# Saab 9-3 - Tab af kølevæske | HELLA

## Loss of coolant

Figure 1

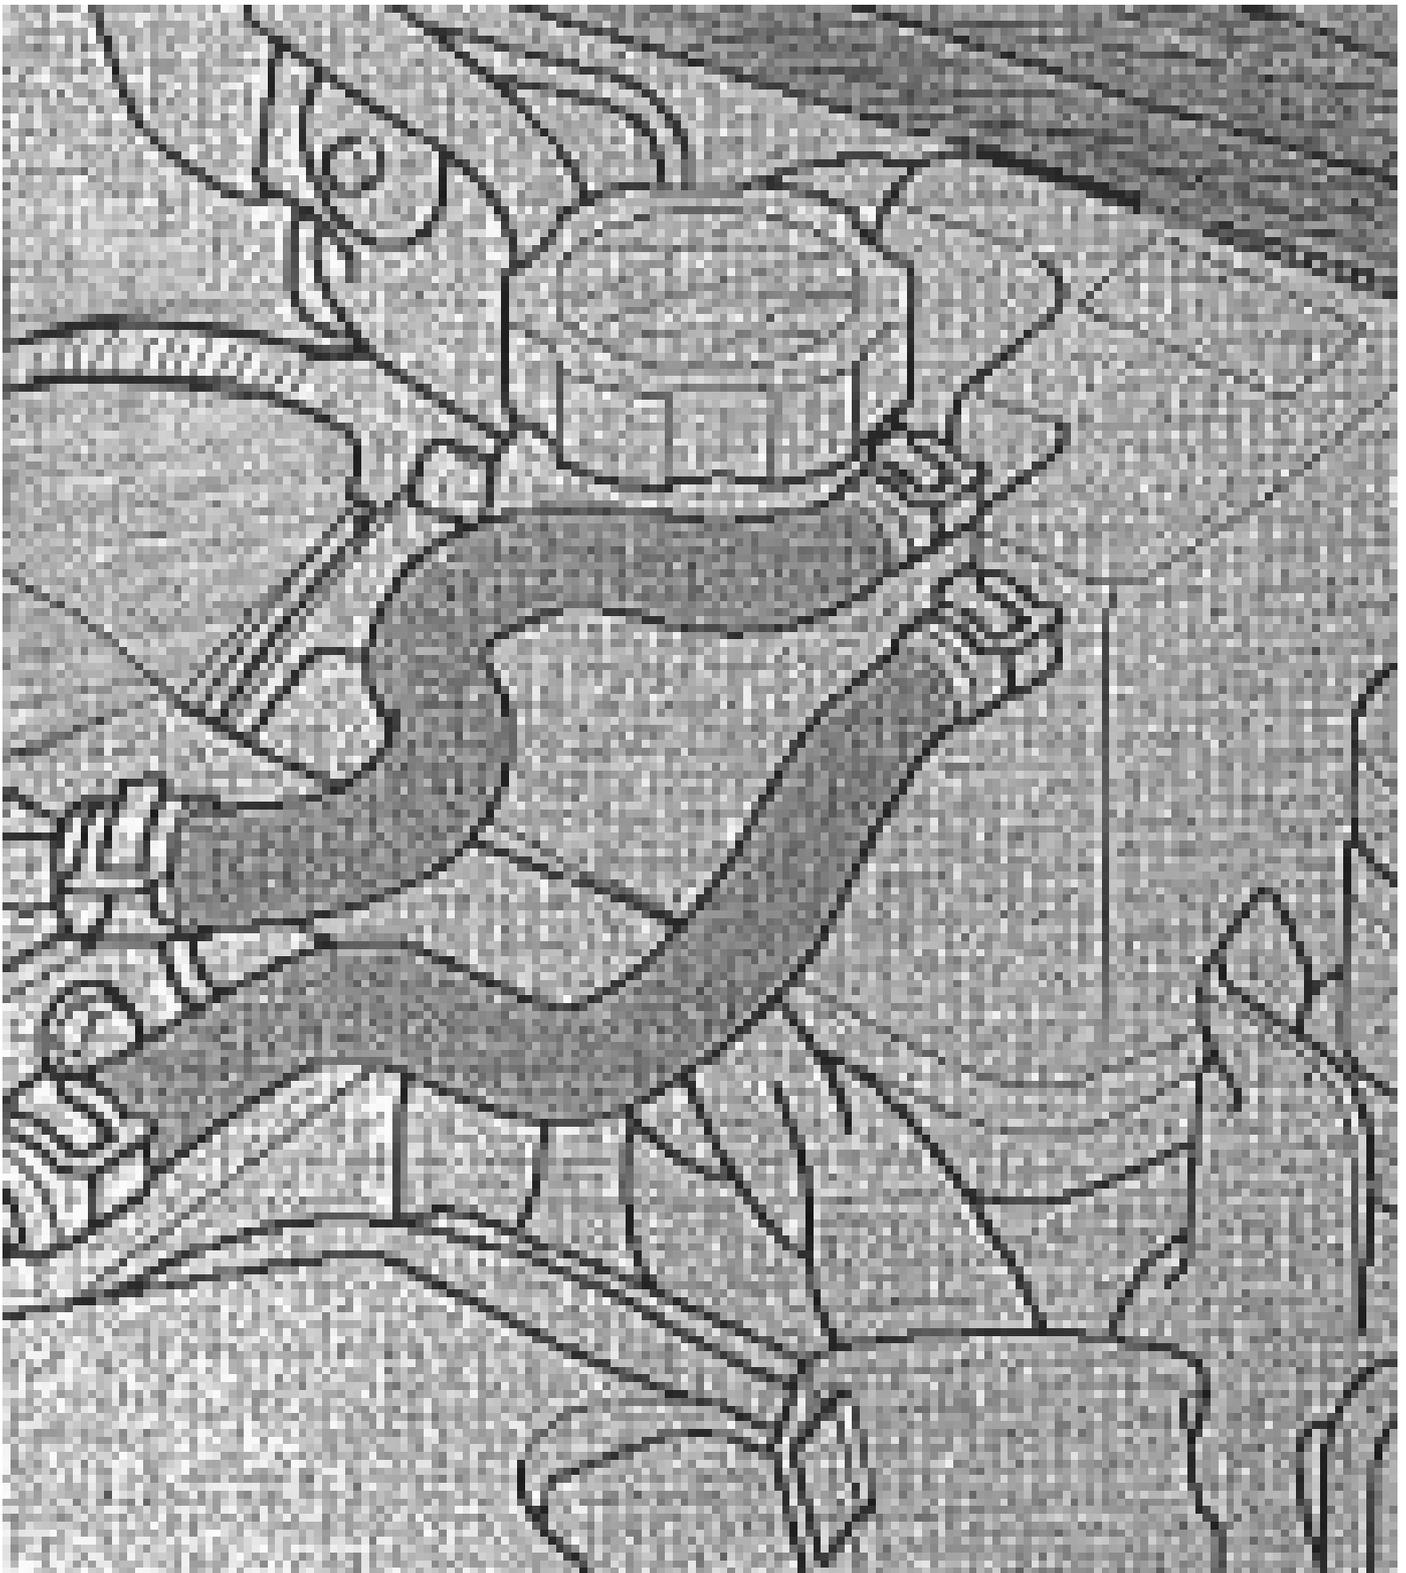
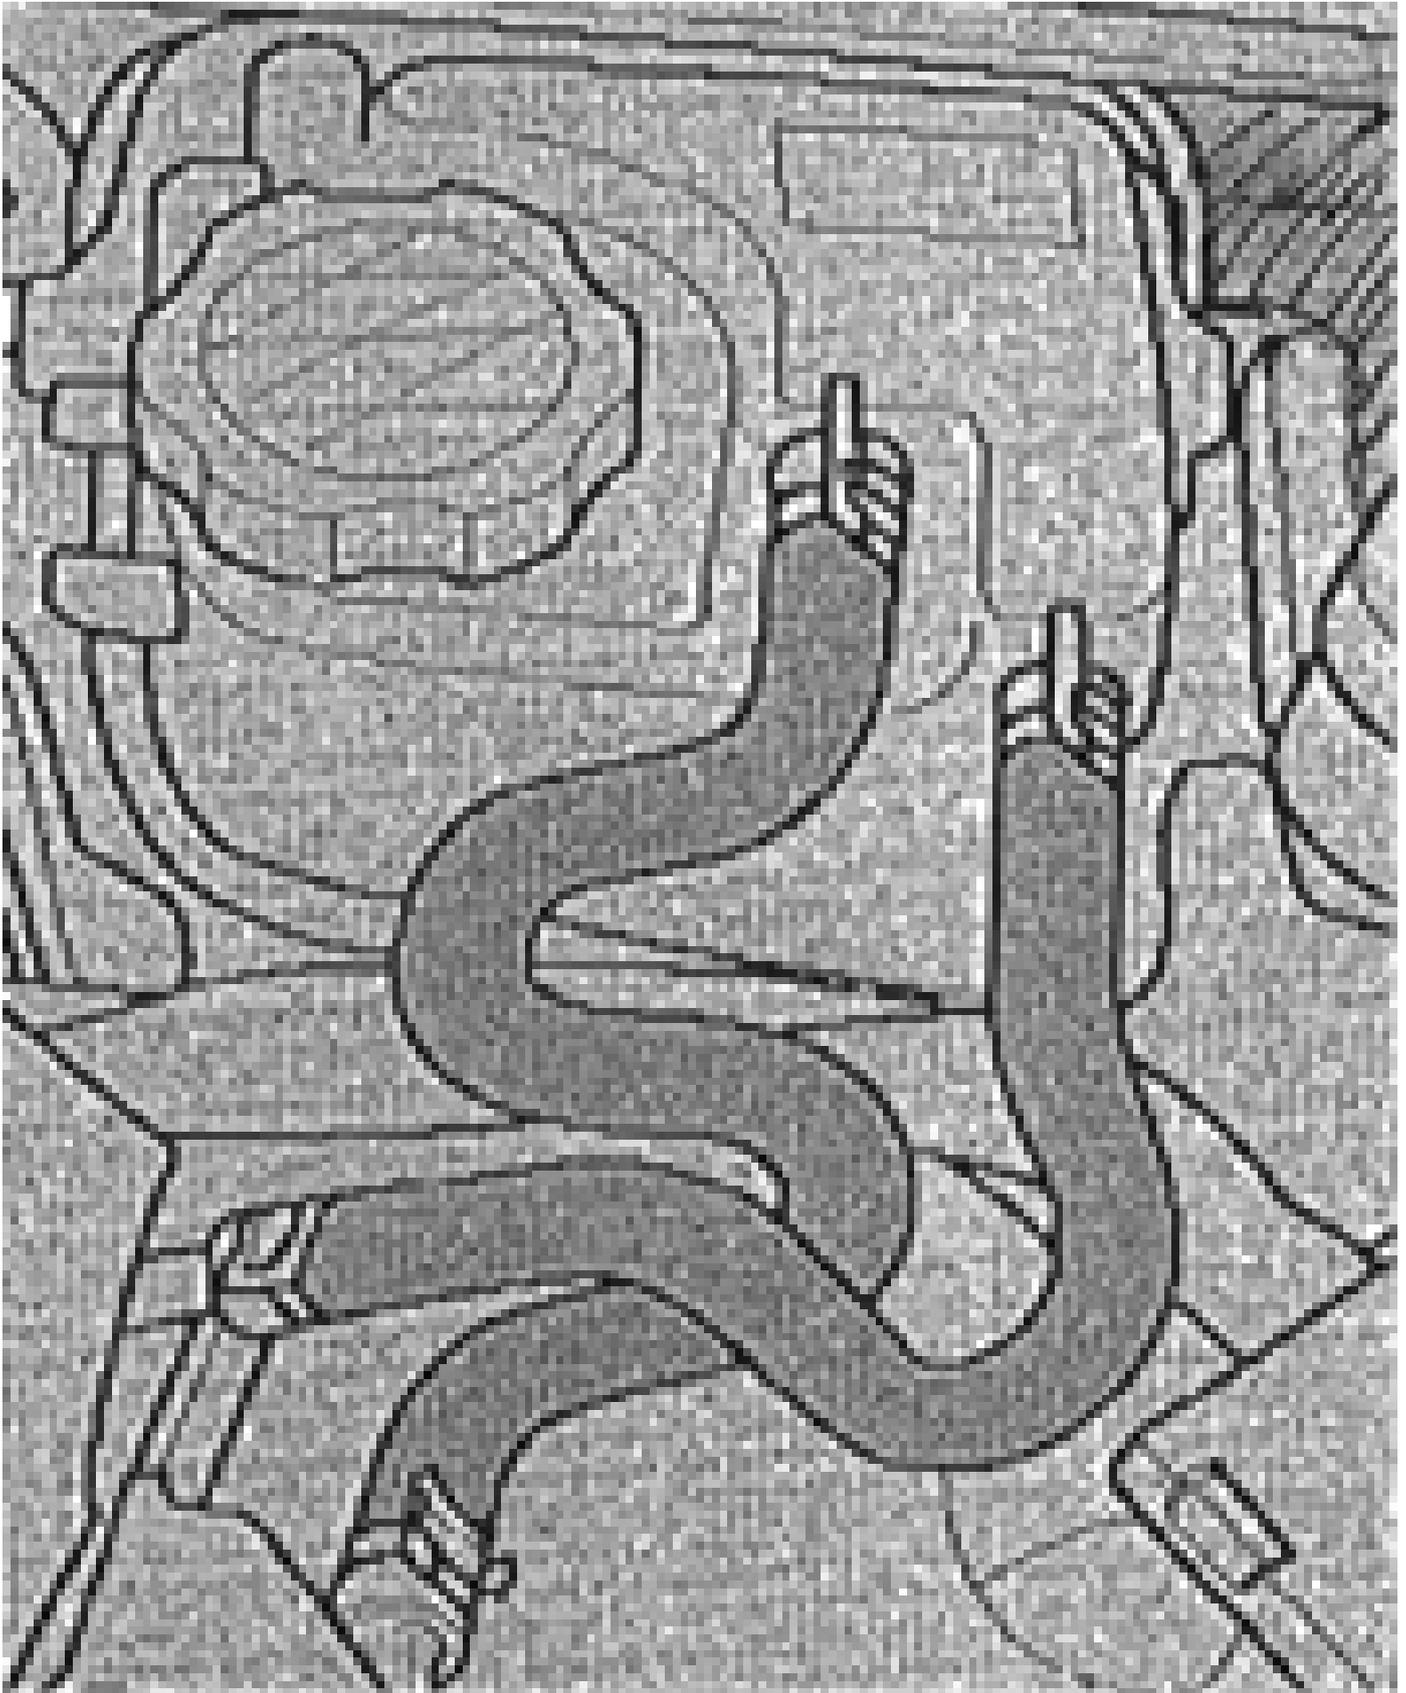
Saab 9-3 Sedan/ st. car Motorkode B284 Stelnummer: 61000001–81107480. Tab af kølevæske For ovennævnte modeller kan blive klaget over tab af kølevæske. Årsagen kan være en fejl ved ekspansionsbeholderen hhv. beskadigede kølevæskeslanger ved ekspansionsbeholderen. Disse komponenter (fig. 1) er placeret meget tæt på turboladeren, hvorved materialerne udmattes som følge af høj omgivende temperatur. Afhjælpning sker ved at udskifte ekspansionsbeholderen og udskifte/omplacere slangerne ved ekspansionsbeholderen. Hertil kan bilfabrikken levere ændrede kølevæskeslanger (se fig. 2). Res.nr. 93 194 927- 1 sæt kølevæskeslanger Res.nr. 12 759 330- 1 ekspansionsbeholder Fig. 1 (gammel udførelse) Fig. 2 (ændret udførelse)

In the case of the above-mentioned vehicles, problems can arise because of loss of coolant. The cause of this can either be a defective coolant expansion tank or damaged engine coolant hoses on the coolant expansion tank.
